Customs Convention on the International Transport of Goods under Cover of TIR Carnets (TIR Convention, 1975):

Amendment proposals to the Convention: Vehicles with sliding sheets

Vehicles and containers with sliding sheets

Submitted by the International Association of the Body and Trailer Building Industry

Sketch No. 9.4

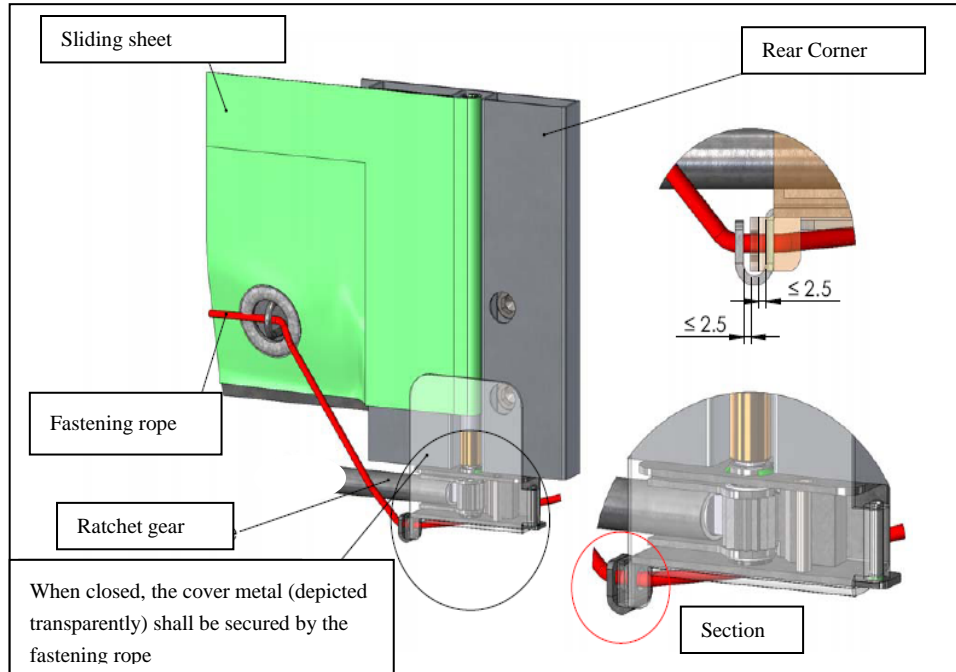
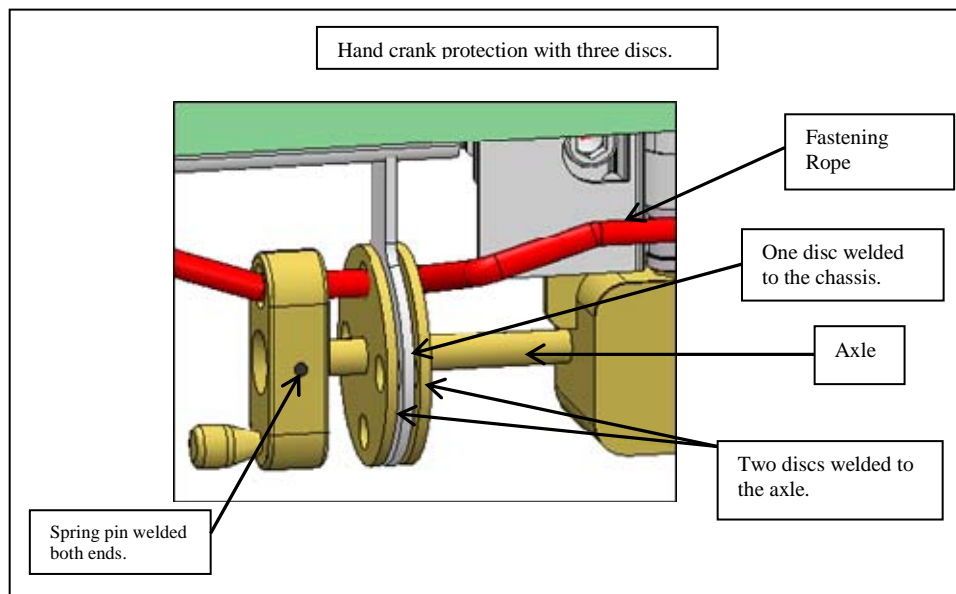
7. For the existing sketch No. 9 substitute

To tighten the sliding sheets in the horizontal direction, a ratchet gear is used (normally at the rear end of the vehicle). This sketch shows two examples, (a) and (b), of how the ratchet or gearbox may be secured.

Sketch No. 9.5

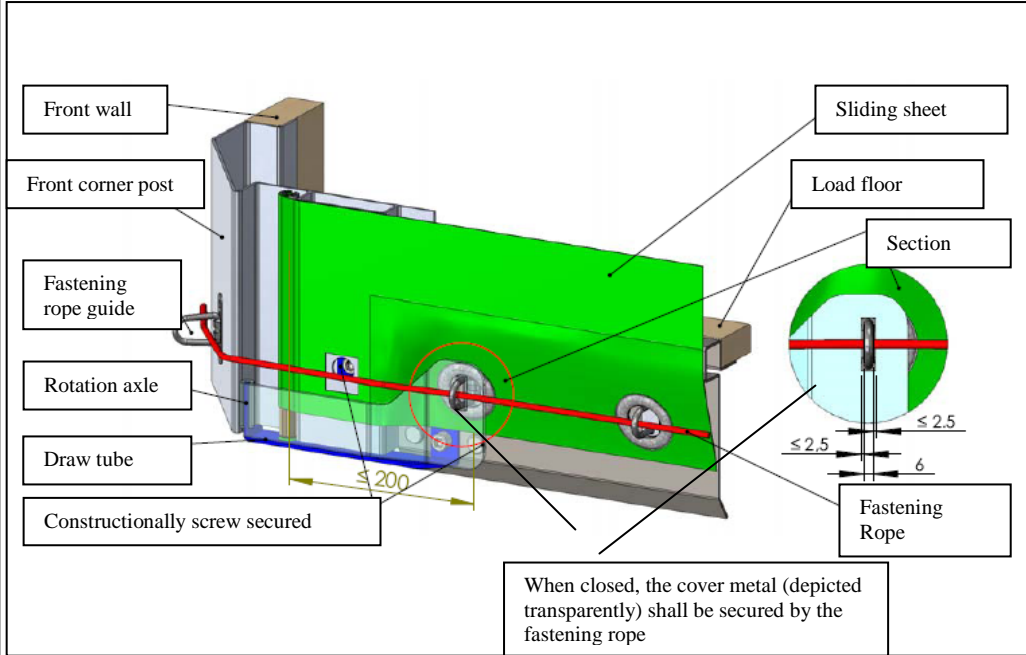
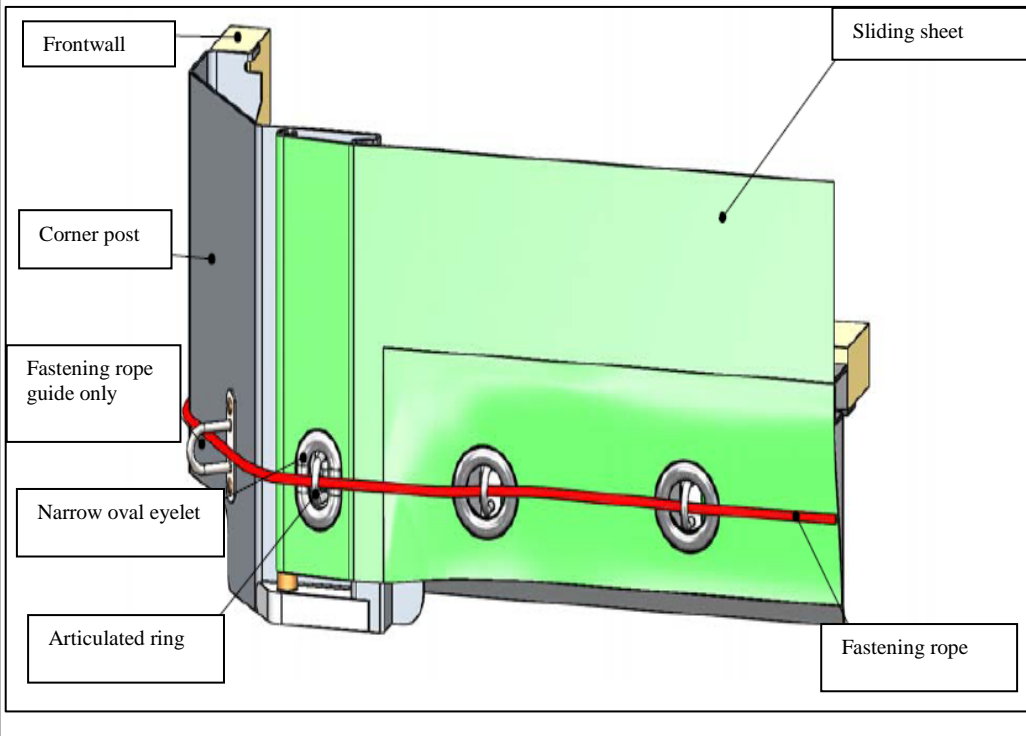
To fix the sliding sheet on the other side (normally the front of the vehicle), the following systems, (a) or (b), may be used.

Sketch No. 10

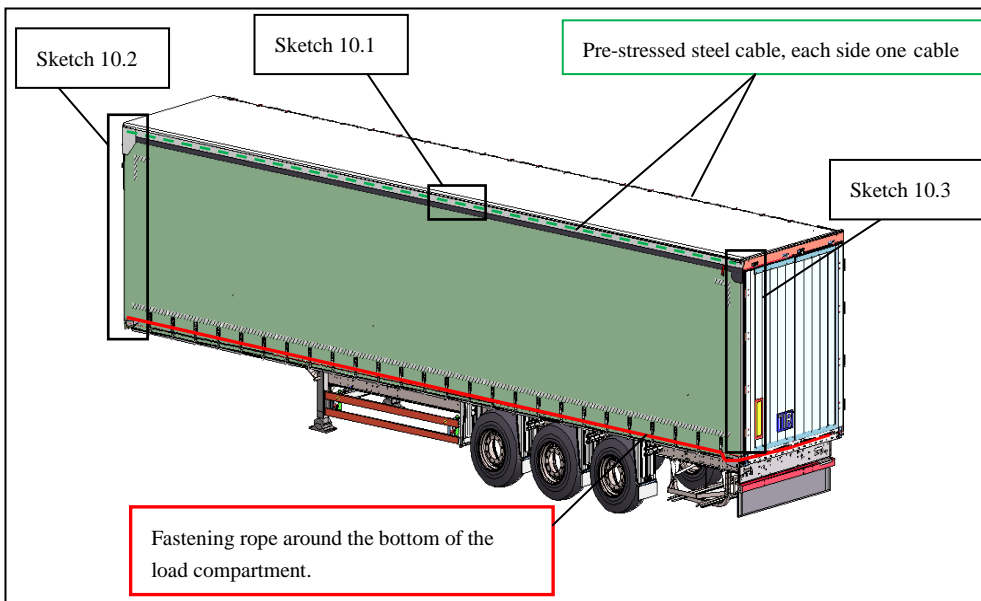
8. Add the following new sketch to the existing sketches appended to Annex 2

This sketch shows an example of a vehicle and the important requirements described in Article 5 of these Regulations.

Sketch No. 10.1

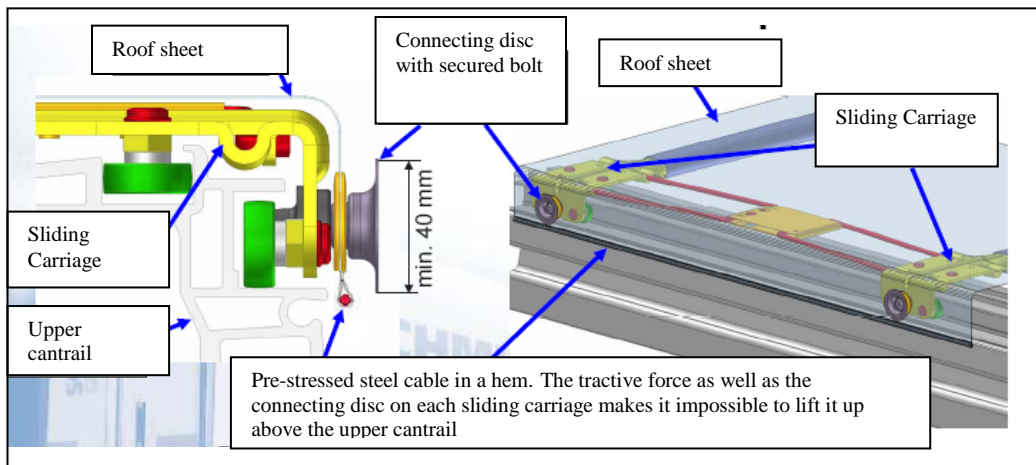
Two pre-stressed steel cables, embedded in a hem, are fixed on each side of the load compartment. This pre-stressed steel cable is fixed to the front (see sketch 10.2) and rear of the body (see sketch 10.3). The tractive force as well as the connecting disc on each sliding carriage makes it impossible to lift up the hem with the pre-stressed steel cable above the upper cantrail.

Sketch No.10.2

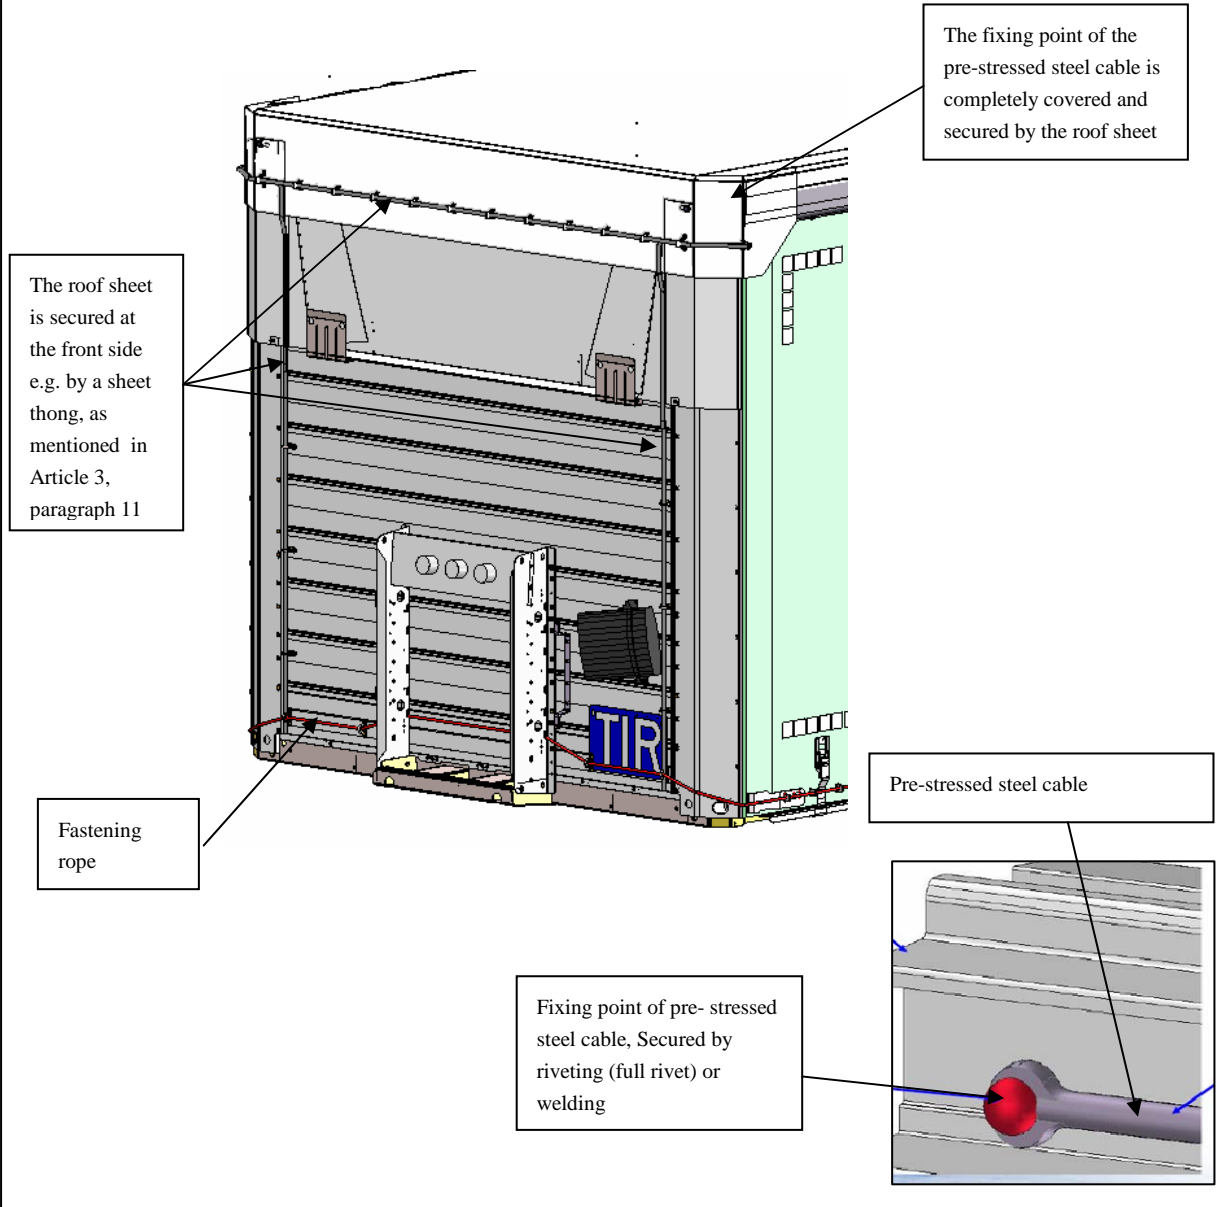
The sliding roof sheet shall overlap with the solid part of the roof at the front side of the load compartment, so that the roof sheet cannot be pulled over the top edge of the upper cantrail.

Sketch No.10.3

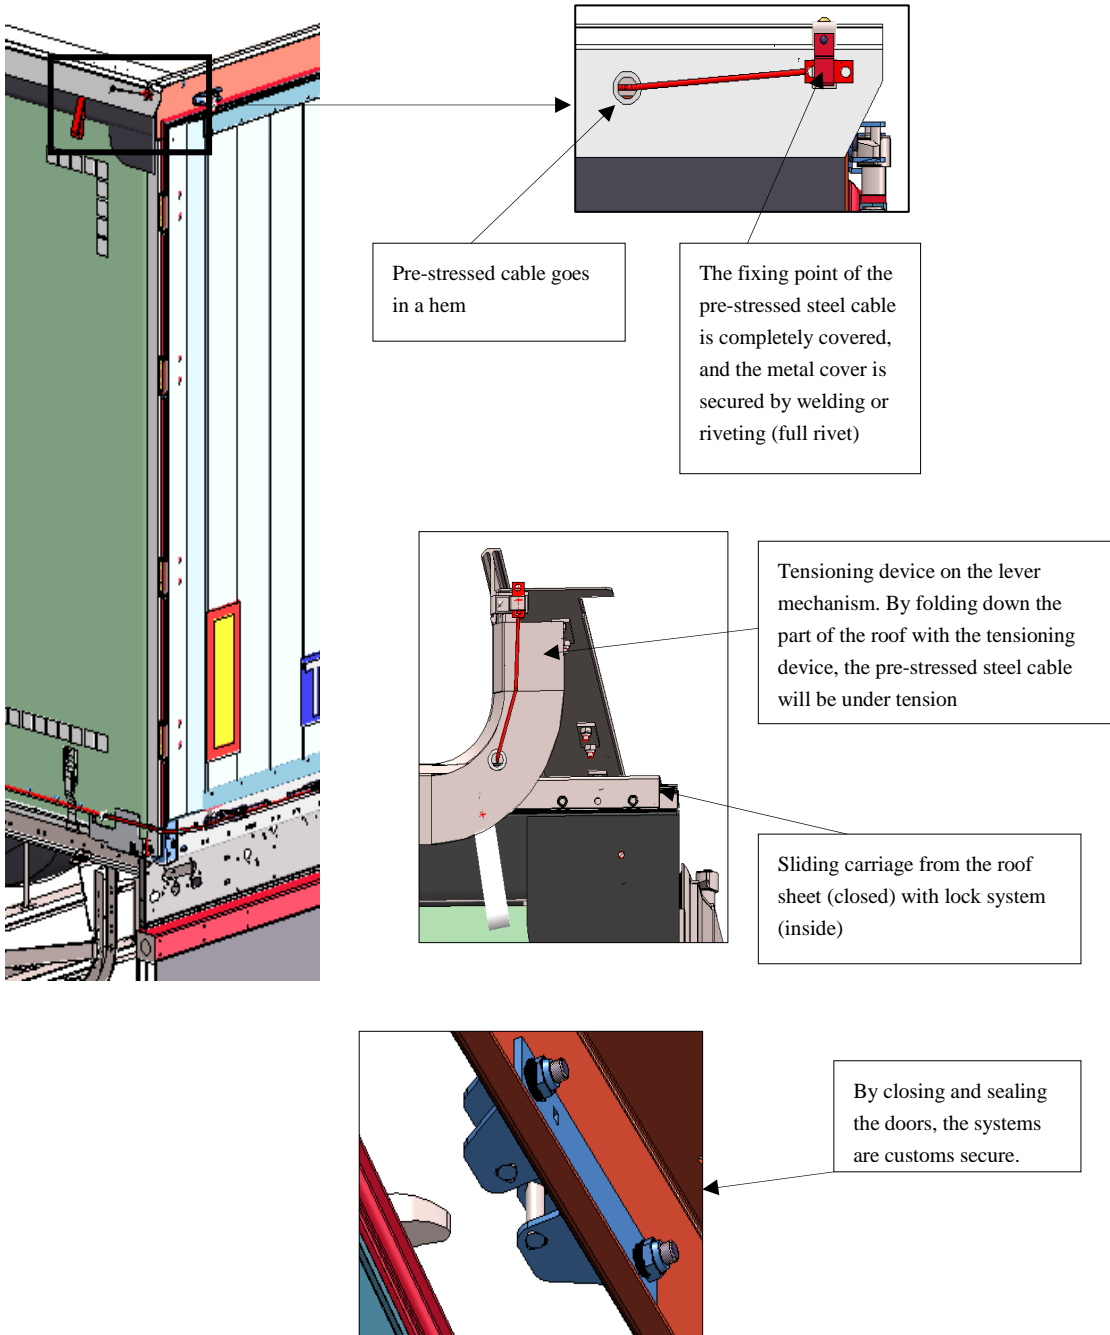
At the rear, a special device, such as a baffle plate, is fitted to the roof, preventing access to the load compartment, without leaving obvious traces when the doors are closed and sealed.

Sketch No. 9.4

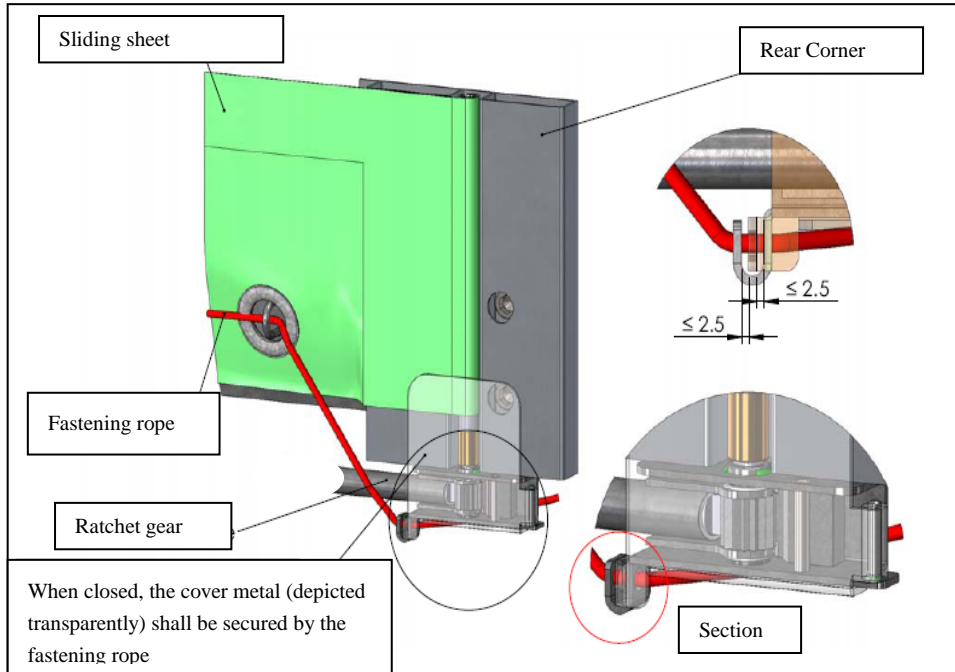
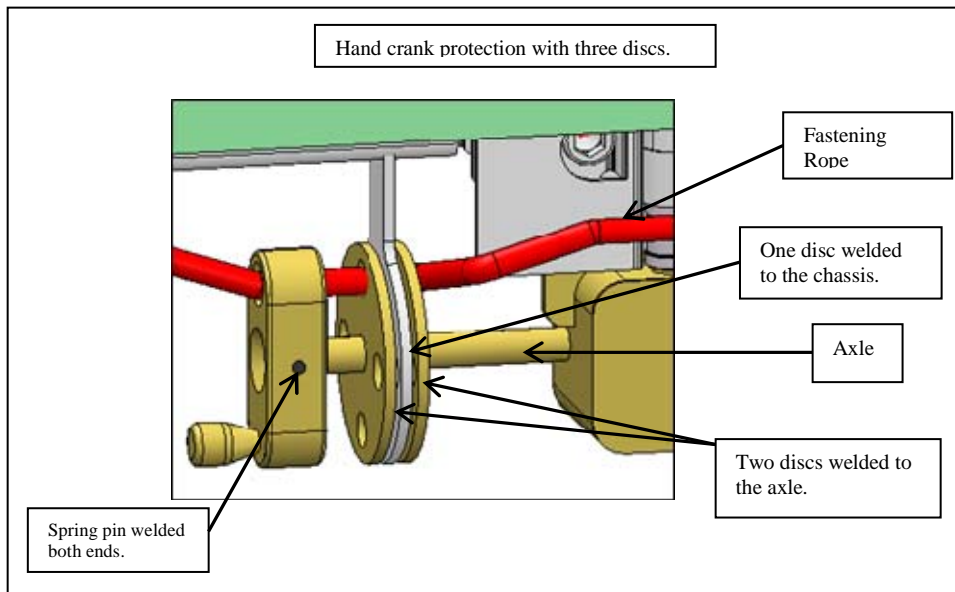
12. For the existing sketch No. 9 substitute

To tighten the sliding sheets in the horizontal direction, a ratchet gear is used (normally at the rear end of the container). This sketch shows two examples, (a) and (b), of how the ratchet or gearbox may be secured.

Sketch No. 9.5

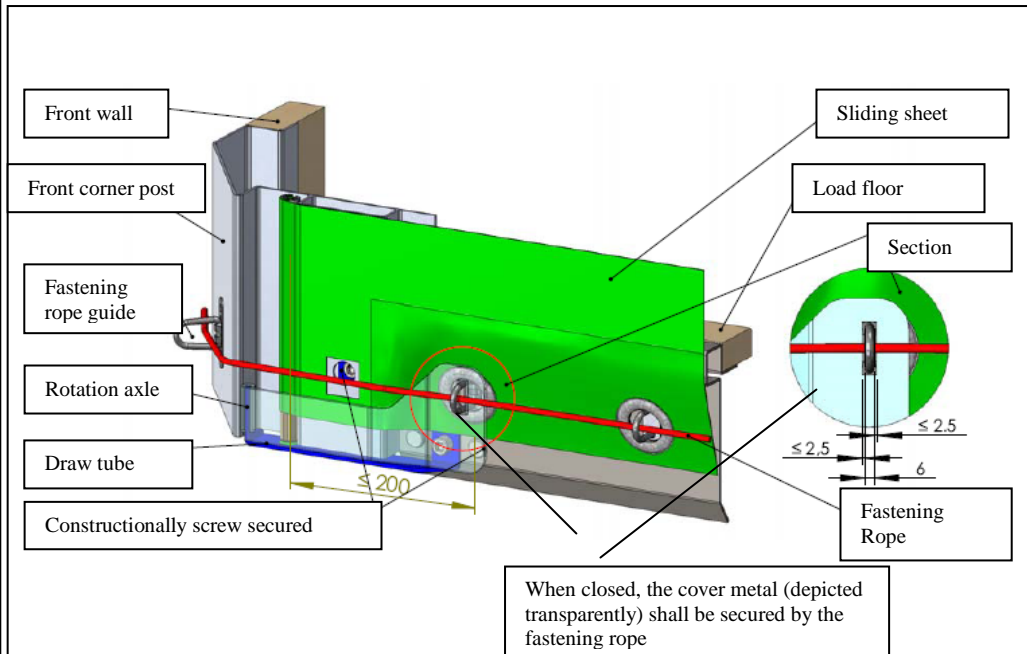
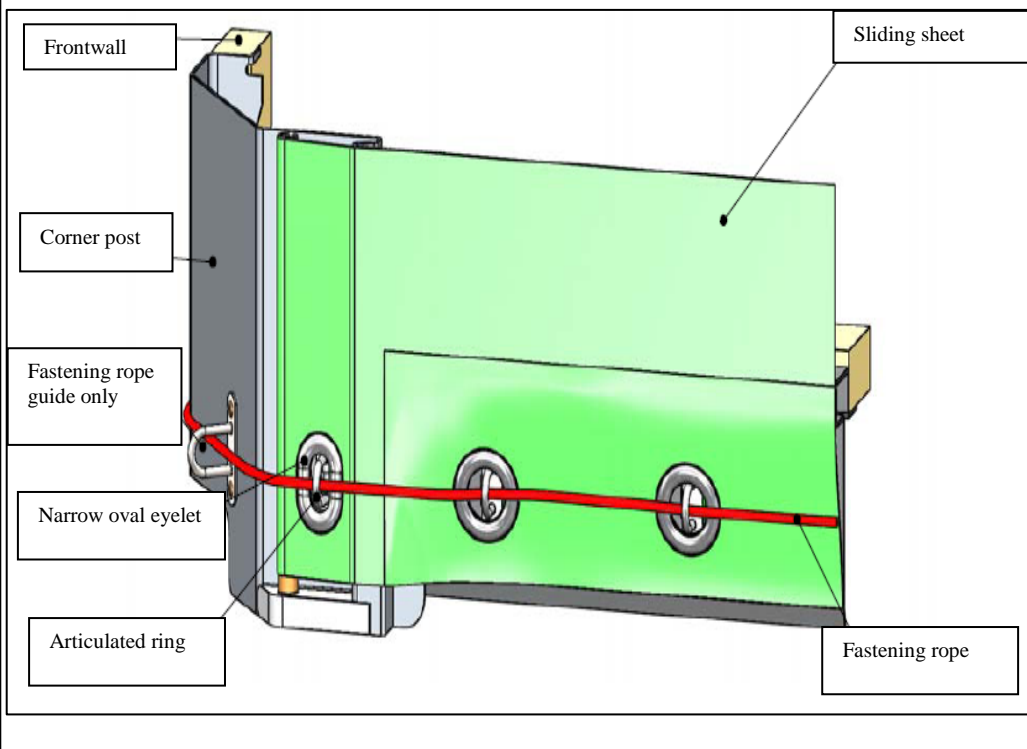
To fix the sliding sheet on the other side (normally the front of the container), the following systems, (a) or (b), may be used.

Sketch No. 10

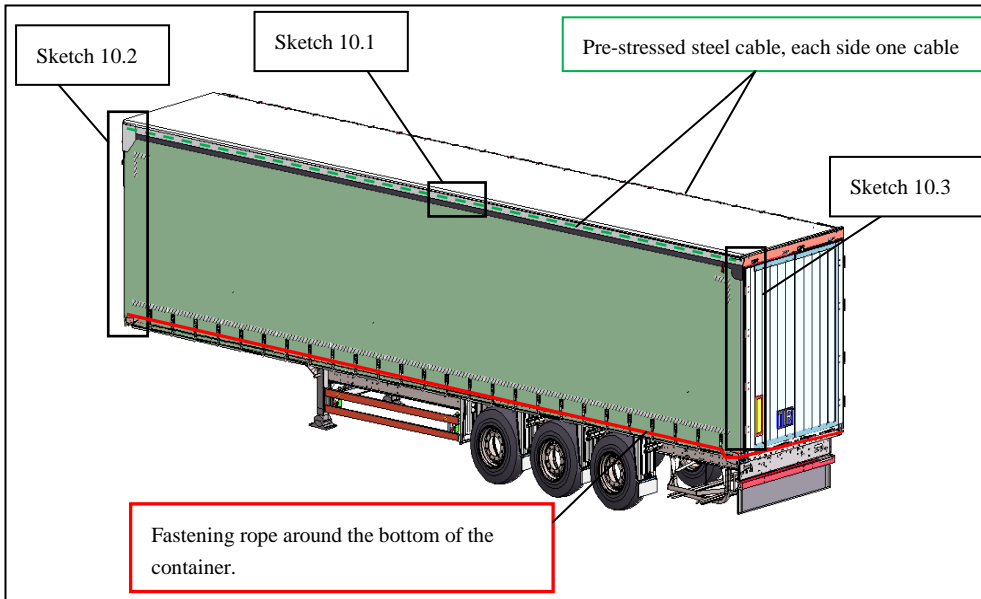
13. Add the following new sketch to the existing sketches appended to Annex 2

This sketch shows an example of a container and the important requirements described in Article 6 of these Regulations.

Sketch No. 10.1

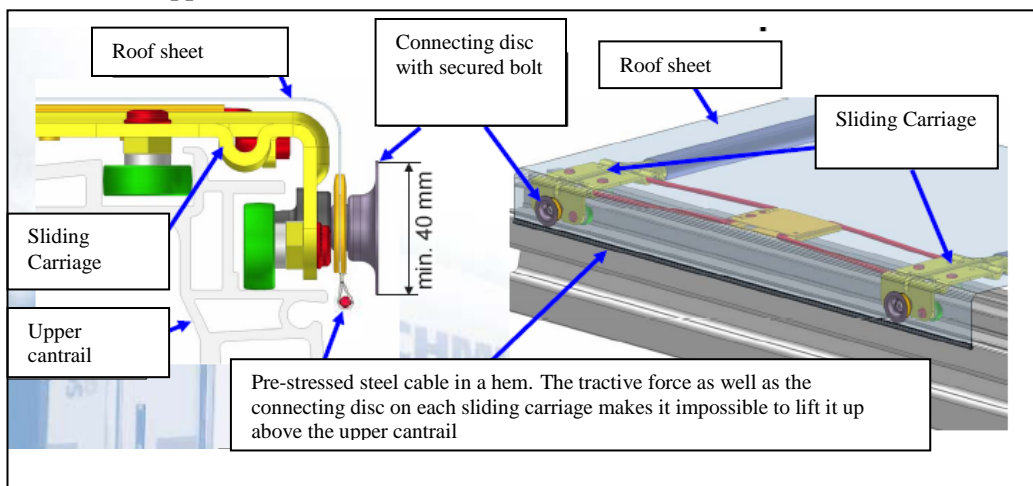
Two pre-stressed steel cables, embedded in a hem, are fixed on each side of the container. This pre-stressed steel cable is fixed to the front (see sketch 10.2) and rear (see sketch 10.3). The tractive force as well as the connecting disc on each sliding carriage makes it impossible to lift up the hem with the pre-stressed steel cable above the upper cantrail.
